Permit Type Building/Residential/Misc/Deck Permit Number B23004403 Opened Date 11/03/2023  
Description of Work SFD/build 14\*16 and 20\*14 with 8.5\*5 corner area of deck with stairs

LOCATION DRAWING  
6309 KERNE COURT  
LOT #29  
MACBETH FARMS  
FLAT M.D.R. NO. 18792  
5th ELECTION DISTRICT, HOWARD COUNTY, MARYLAND  
FOR N.Y. HOMES

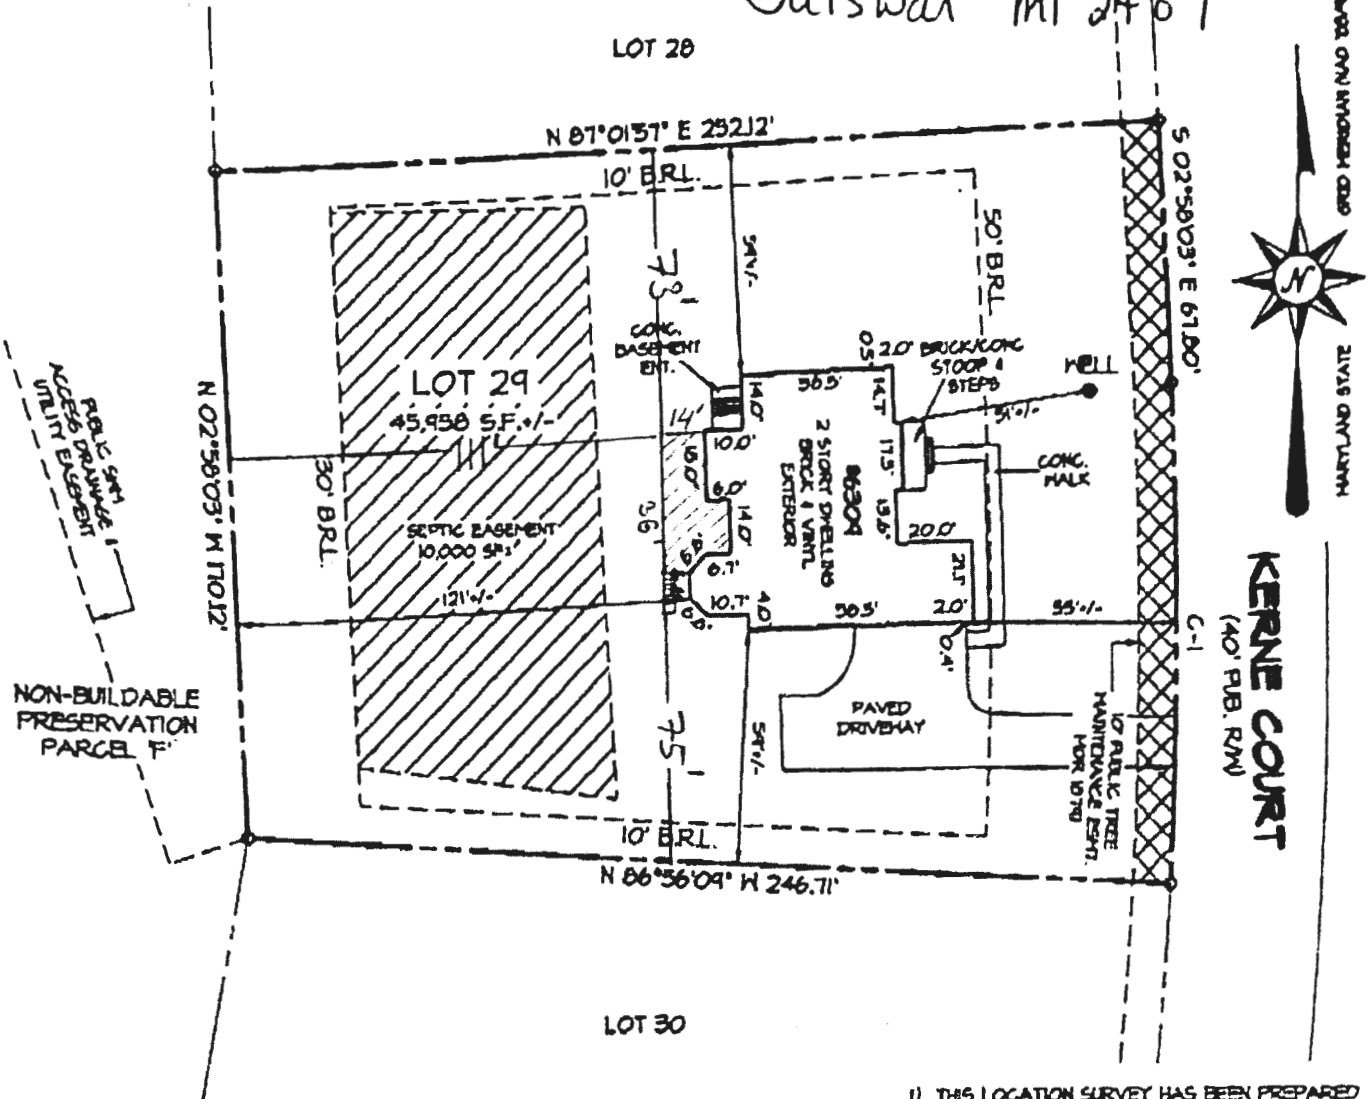
No notification received from DILL

Expedite.  
gls 12/18/23

Approved.  
gls 12/13/23
